RECALL BULLETIN:
180817REV

PRODUCT(S) AFFECTED:

Inspection/
Correction
of Diesel
Generator
Exhaust Pipe
Routing

October 2018

Figure 1
Exhaust pipe is correctly routed as shown located exiting below the rear compartment door latch and extending beyond the sidewall.

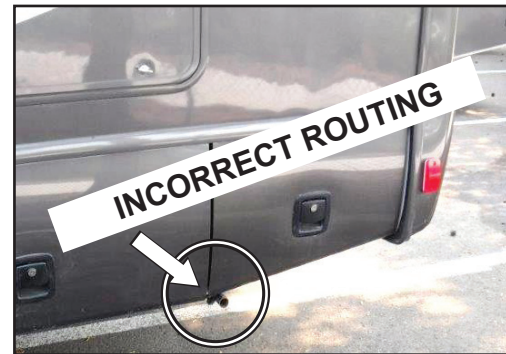
4. **Figure 1 is an example of the correct location for the generator exhaust pipe, located just below the compartment latch. Inspection procedure follows:**

- a) If the generator exhaust pipe extends past the outside of the sidewall (1" minimum see example in Figure 3) continue on.
- b) Using a mechanic's creeper, check underneath the vehicle to determine whether the generator exhaust pipe is routed too close to the gray waste-water tank. (A proper routing is minimum of 4" away from the gray waste-water tank).

Figure 2
Exhaust pipe is improperly routed at an angle and exits near the front of the last roadside luggage compartment

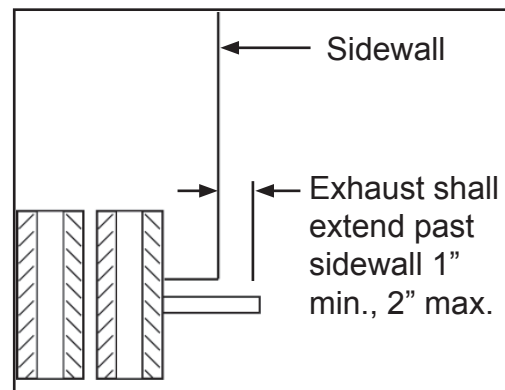
- c) **Figure 2 is an example of improper routing. Inspect the positioning of the generator exhaust pipe, if it is located between the two rear compartment doors go to step D.**
- d) Using a mechanic's creeper, check underneath the vehicle to determine whether the generator exhaust pipe is routed too close to the gray waste-water tank, (**proper routing is minimum of 4" away from the gray wastewater tank**)

- e. If the generator exhaust is improperly routed, take clear photos and submit with a Prior Authorization Request (PAR) before proceeding to the Correction Procedure (Step 5).

Figure 4

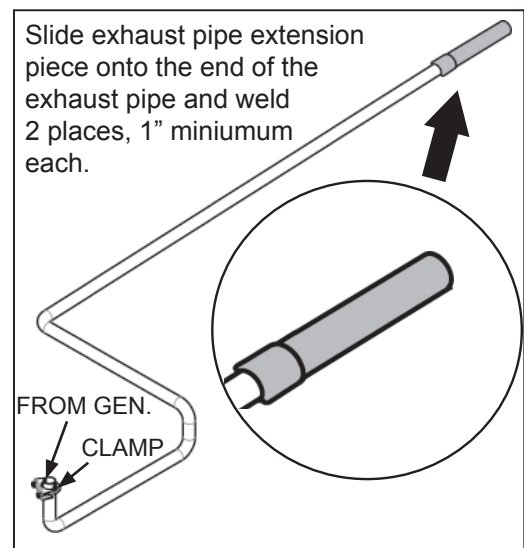
7. Take the exhaust pipe to a work area.
8. Locate the generator exhaust pipe extension piece, included with the recall kit. Slide the flared end of the extension piece over the end of the exhaust pipe until it overlaps a minimum of 1 1/2". Weld in two places, 1" minimum each place. Refer to Figure 4. **Extensions must be welded and NOT clamped.**
9. Return the exhaust pipe to the vehicle and reattach it to the generator exhaust outlet using the original clamp at the generator.

Figure 5

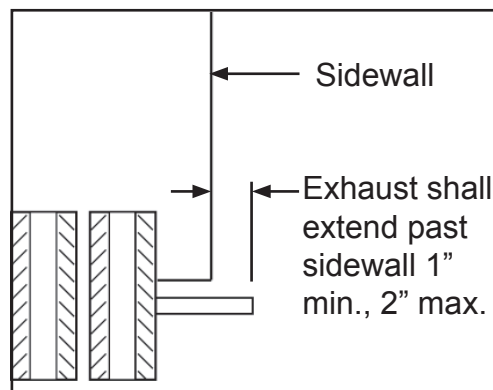
10. Route the exhaust pipe to exit perpendicular to the sidewall, as shown in Figure 5. Ensure it is a minimum of 4" away from the gray waste-water tank, or any other combustible components. Install exhaust hangers (included with the recall kit) to properly support the pipe.

IMPORTANT NOTE: The exhaust pipe must extend a minimum of 1 inch (25 mm) beyond the sidewall of the vehicle. See Figure 6. Support with tailpipe hangers included with the kit. Ensure hanger brackets are securely fastened to chassis components using the bolts, flat washers, and nuts, or the screws and flat washers, included in the recall kit. (See Page 5 for Part requirements.)

11. Trim excess length from the end of the new exhaust pipe extension as necessary, **ensuring a distance of 1" minimum / 2" maximum beyond the outside of the sidewall is maintained.** See Figure 6.
12. When the repair has been completed, take photos to submit with the repair claim.
